UNITED STATES PATENT AND TRADEMARK OFFICE

| APPLICATION NO. | FILING DATE | FIRST NAMED INVENTOR | ATTORNEY DOCKET NO. | CONFIRMATION NO. |
|--|-------------|----------------------|---------------------|------------------|
| 10/628,613 | 07/29/2003 | Fraser Evans | MBT-105-B | 5830 |

| Office Action Summary | Application No. | Applicant(s) | |

DETAILED ACTION

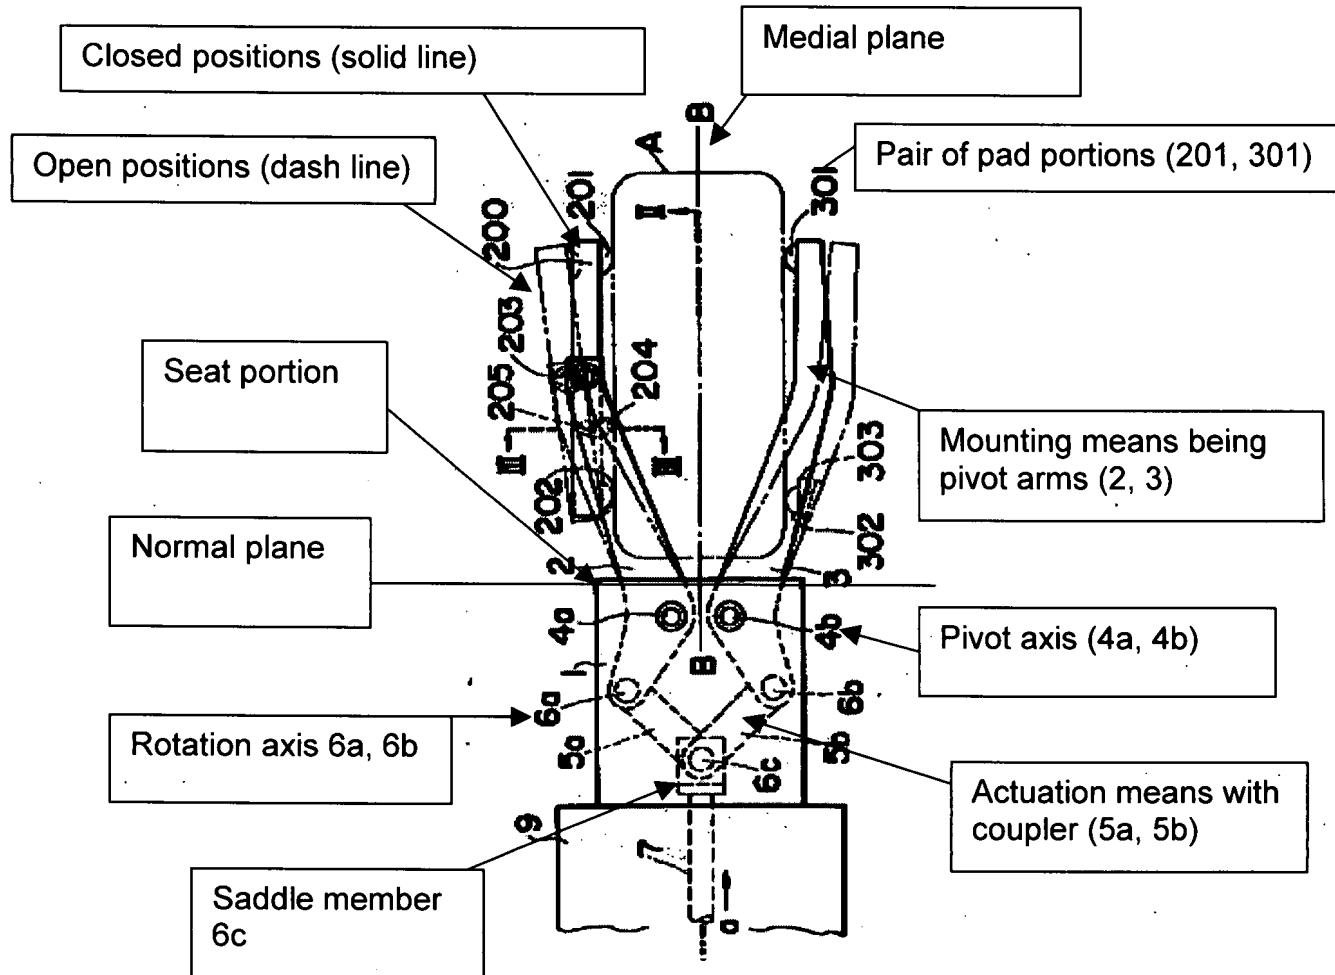
Claims 1-4, 9, 10, and 12 as best understood stand rejected under 35 U.S.C. 102(b) as being anticipated by Asamoto (US patent no. 3,945,676).

Asamoto discloses a clamp apparatus having all the claimed features of applicant's invention as illustrated below.

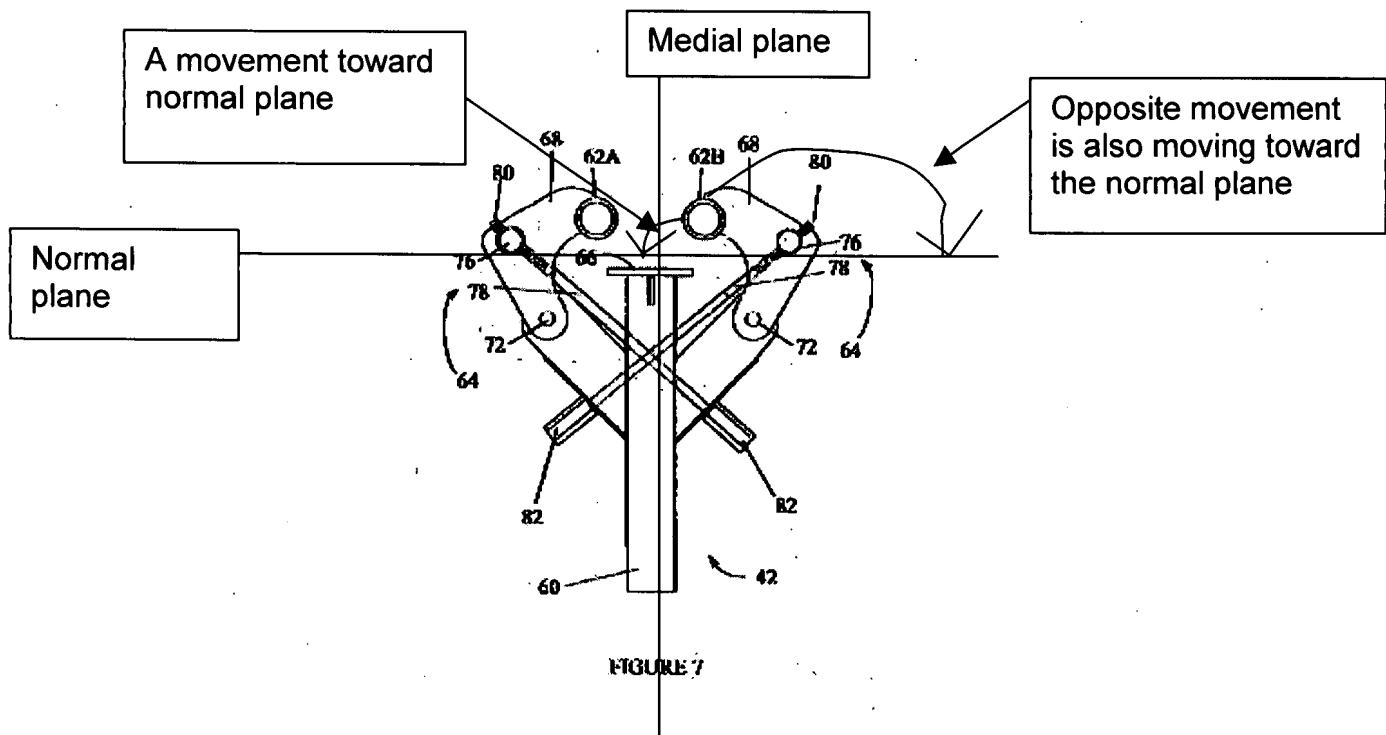
Applicant's arguments filed 4/11/2007 have been fully considered but they are not persuasive. Applicant argues that Asamoto does not show the pad portions move away from the normal plane, from the closed positions to the open positions, at least the second pad portion move away from the medial plane. Examiner has noted the following; In claim 1, applicant's newly added recitation "wherein during movement **from the open positions to the closed positions**, the first pad portion moves in a direction away from the normal plane, and the second pad portion moves in a direction away from both the medial plane and the normal plane" in claim 1, second paragraph which appears to be contradictory to claim 9 which says that "during movement **from closed positions to open positions**, the pad portions move (also) in a respective directions ways from the normal plane and the medial plane".

However, such does give examiner new insight on the claim language. The medial plane and the normal plane extends through to either side of the pad motion, such that the pad can be said to move away or toward the planes from the closed to open or vice versa which says such limitation is meaningless as direction goes and does not overcome Asamoto at all. (see illustration below).

Again applicant's recitation does not overcome Asamoto as illustrated above.

Movement of the pad portions can be said to be moving towards and away from a particular plane at the same time where such plane extends through the fulcrum of the swing arm with the pad portions on its left and right side as illustrated above. If the arm

is swinging right then it can be said the arm is moving towards the right portion of the plane but away from the left portion of the plane and vice versa.
